SERVICE BULLETIN SPSB009

SUBJECT: SUPPLIER/VENDOR RECALL OF PS70104 HOUSINGS (METAL FLEX HOISING INC)

STATUS: MANDATORY INSPECTION AND REPLACEMENT OF RECALLED HOUSINGS

ALL JA101-XX HARNESS CONTAINER ASSEMBLIES (JAVELIN ODYSSEY) WITH METAL FLEX HOISING BATCH # 33234 A AND 33227, .375ID PS70104 HOUSINGS. SEE SERIAL NUMBER LIST BELOW.

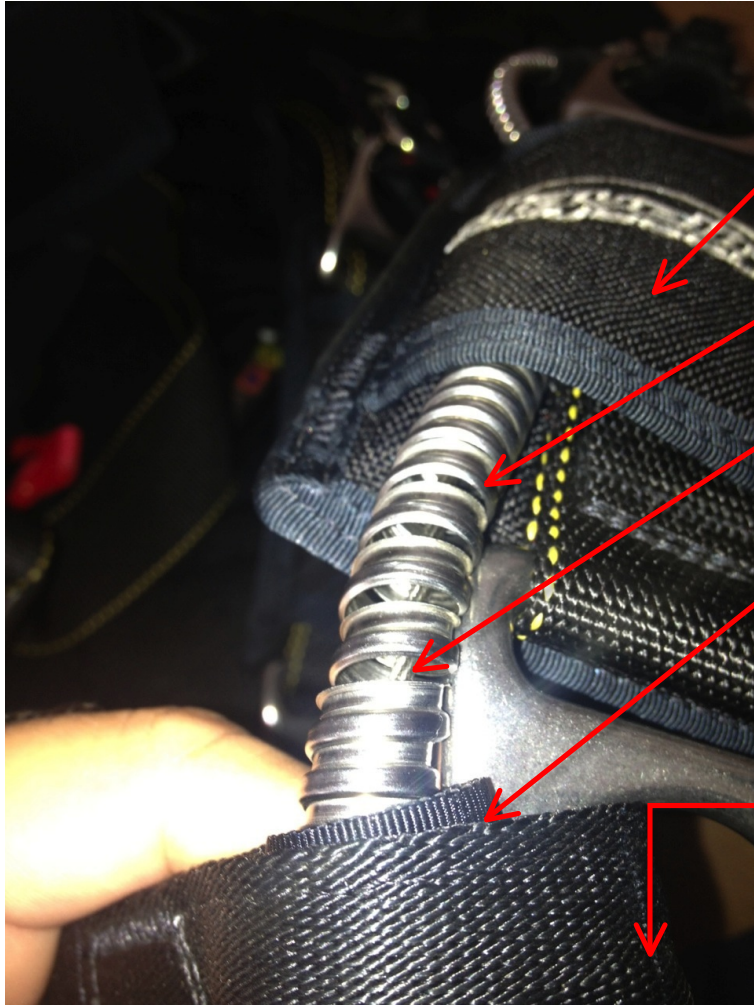
Who can inspect: Anyone can inspect this area. See photos below.

WEARERS LEFT SIDE:

RING COVER

RESERVE RIPCORD HOUSING (LOWER END)

SEPERATED HOUSING (FOR REFERENCE)

CHEST STRAP BUFFER

CHEST STRAP

What to inspect: All JA101-XX harness container systems listed in table above. Inspect Reserve Ripcord housing.

If the serial number is listed in the above table, inspect the available exposed reserve ripcord housing. Locate the lower end of the housing, which is clamped to the Main Lift Web, just above the reserve ripcord pocket. Inspect the exposed length of housing from the clamp upwards; ensure that the coil has not separated/unraveled. Be sure to inspect the section that is routed through the chest strap.

A. HOUSING FOUND TO BE INTACT (GOOD): The rig may continue to be jumped with periodic monitoring until the next repack cycle or earlier elective replacement. However this housing must be replaced at the next repack cycle. See <http://www.sunpath.com/support/HousingReplacement.pdf> for instructions for your rigger to complete the replacement of the housing.

B. HOUSING FOUND TO BE SEPERATED/UNRAVELLED (BAD): The housing must be replaced before the next jump by a certificated senior or master parachute rigger (or foreign equal) or the manufacturer. See <http://www.sunpath.com/support/HousingReplacement.pdf> for instructions for your rigger to complete the replacement of the housing or instructions to send your system back to the manufacturer.
